**RE: Belvedere Beach, Lot 46A
TM 32 BLK 24 P 427
Tax Account # 3115-1307-3200**

ADMINISTRATIVE SITE PLAN

CONFIRMATION OF PRE-FILE MEETING

Variance to allow a two-story dwelling with less setbacks than required

PROPOSED DEVELOPMENT PLAN
SCALE: 1"=20'

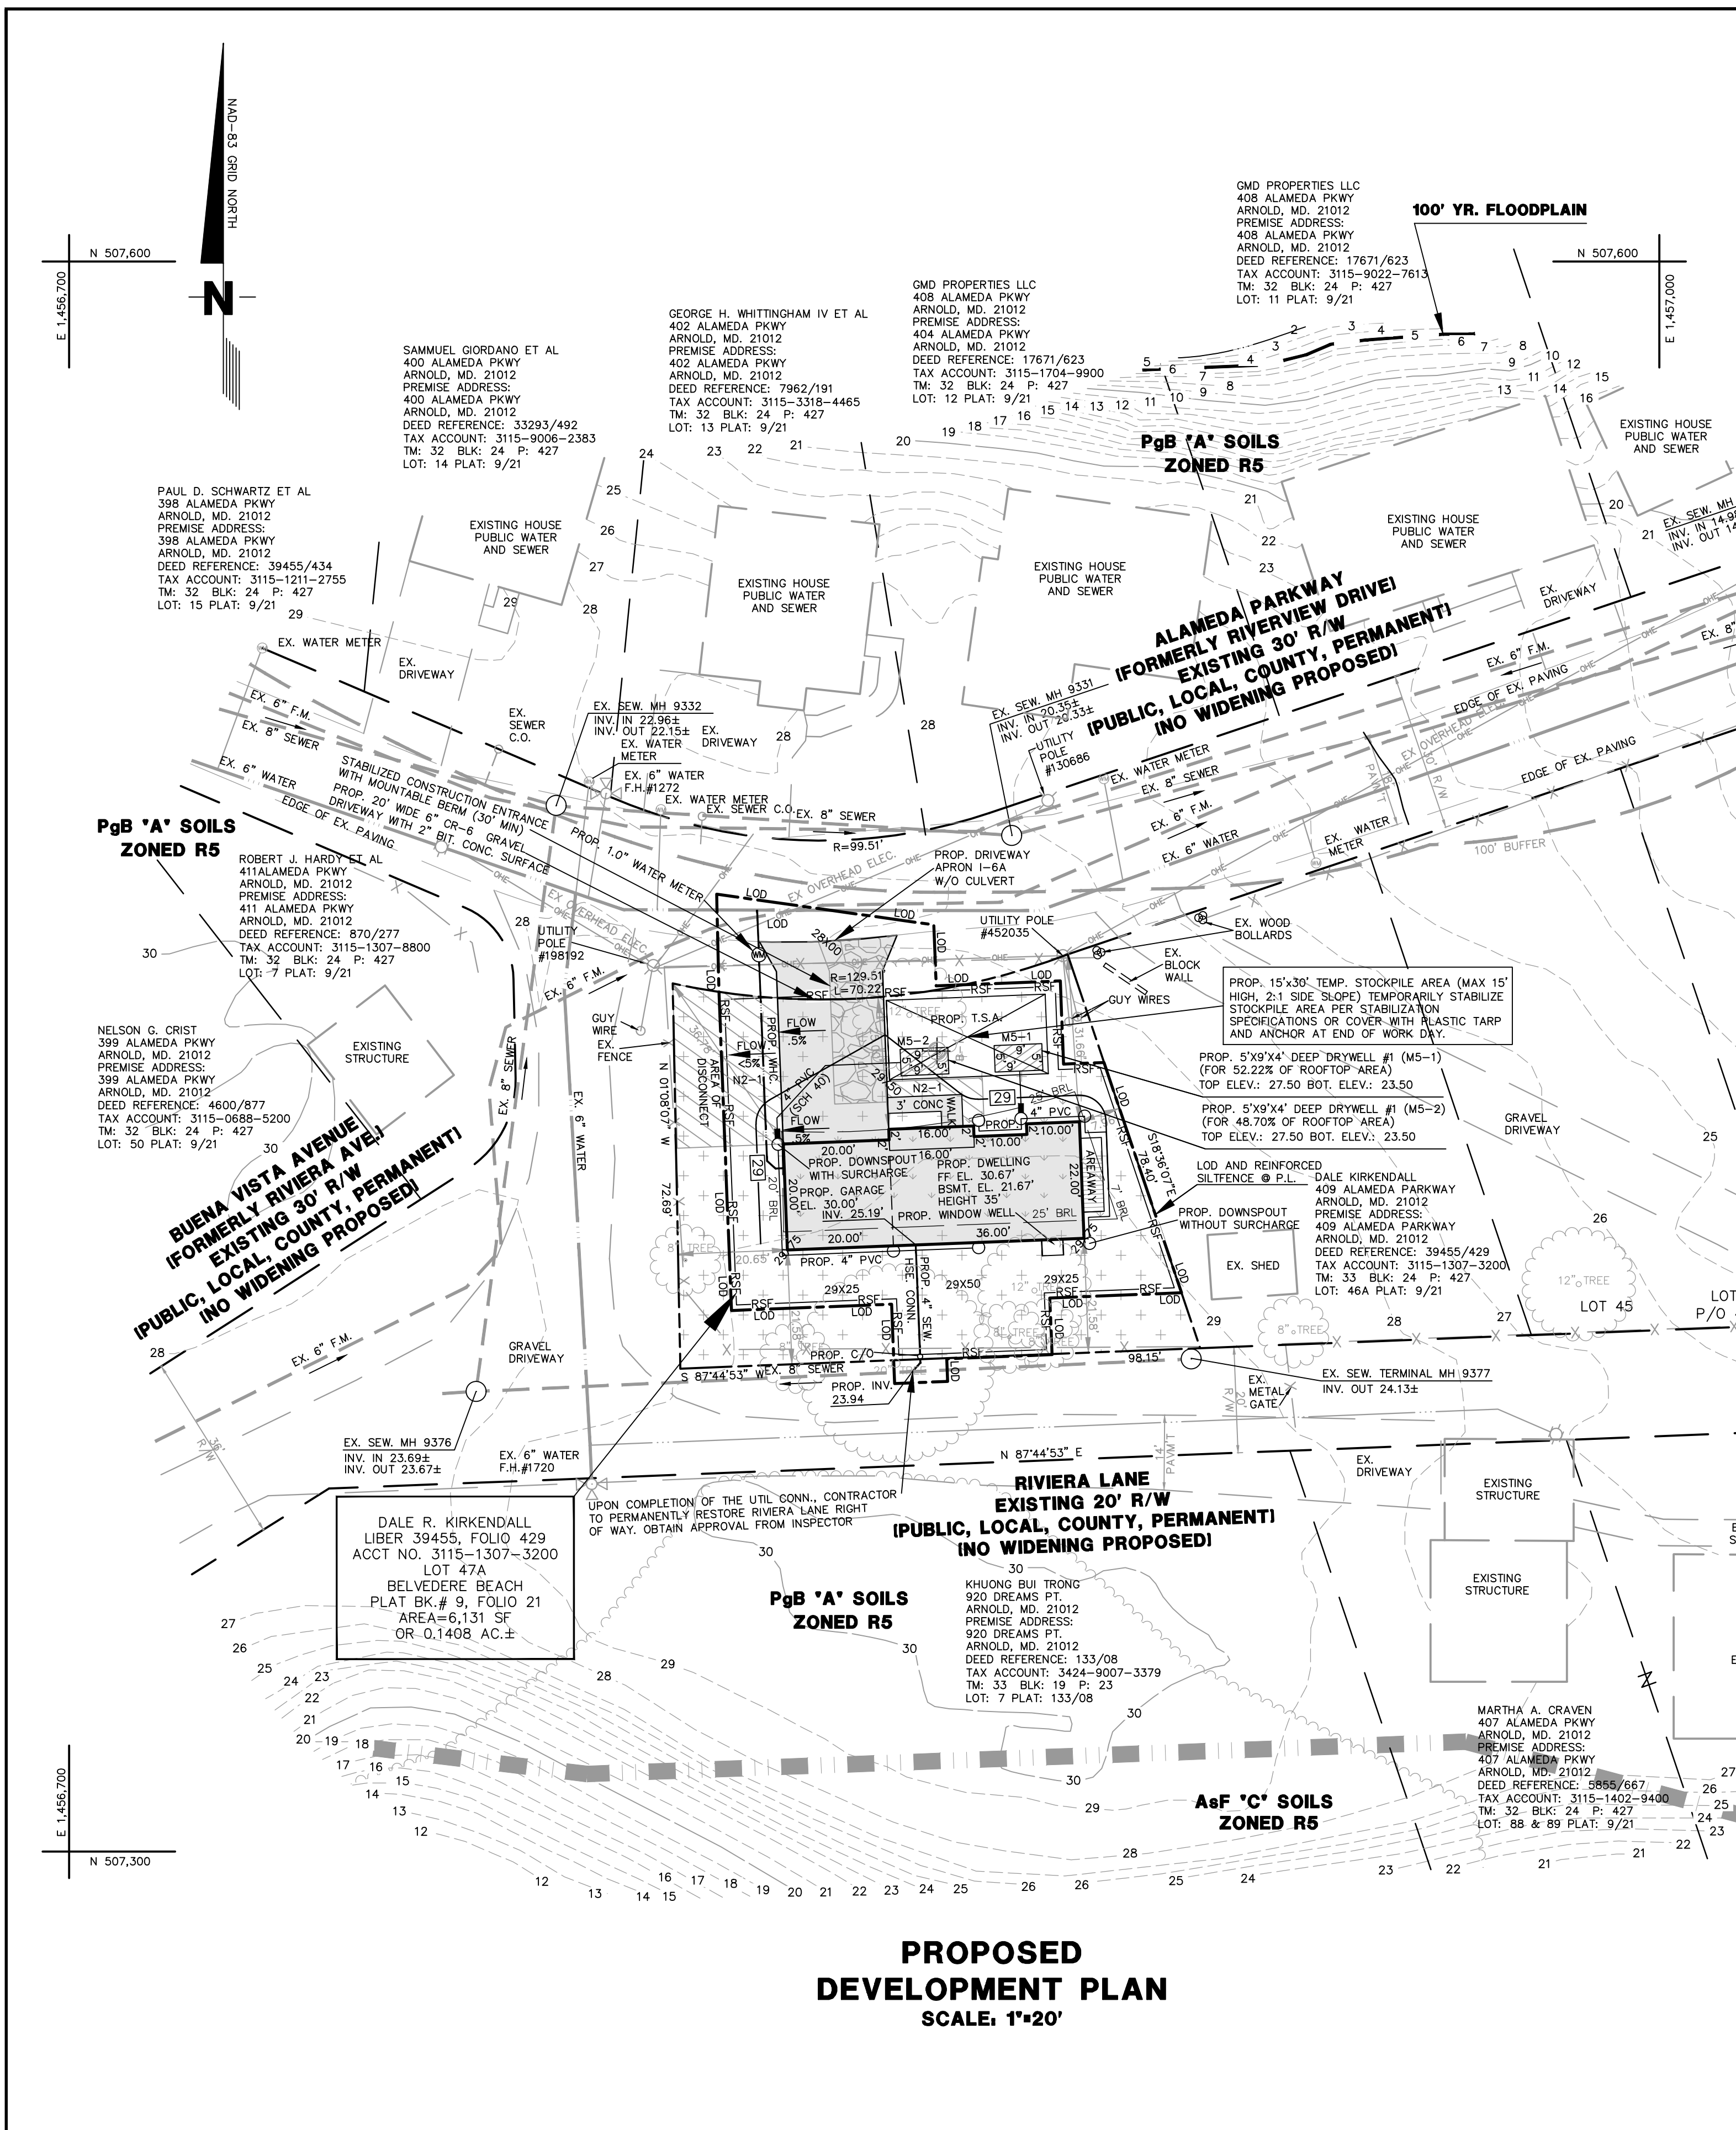
Engineering – The siting and suitability of the shown drywells needs to be confirmed. No soil borings were submitted with the pre-file.

Zoning – Corner through lot is unique and does appear to create a practical difficulty. Site Plan with exception of SWM appears to be sufficient for variance submittal.

Engineering – The siting and suitability of the shown drywells needs to be confirmed. No soil borings were submitted with the pre-file.

Zoning – Corner through lot is unique and does appear to create a practical difficulty. Site Plan with exception of SWM appears to be sufficient for variance submittal.

Response: This has been provided and reviewed under grading permit G02019946

Response: SWM has been provided and reviewed under grading permit G02019946
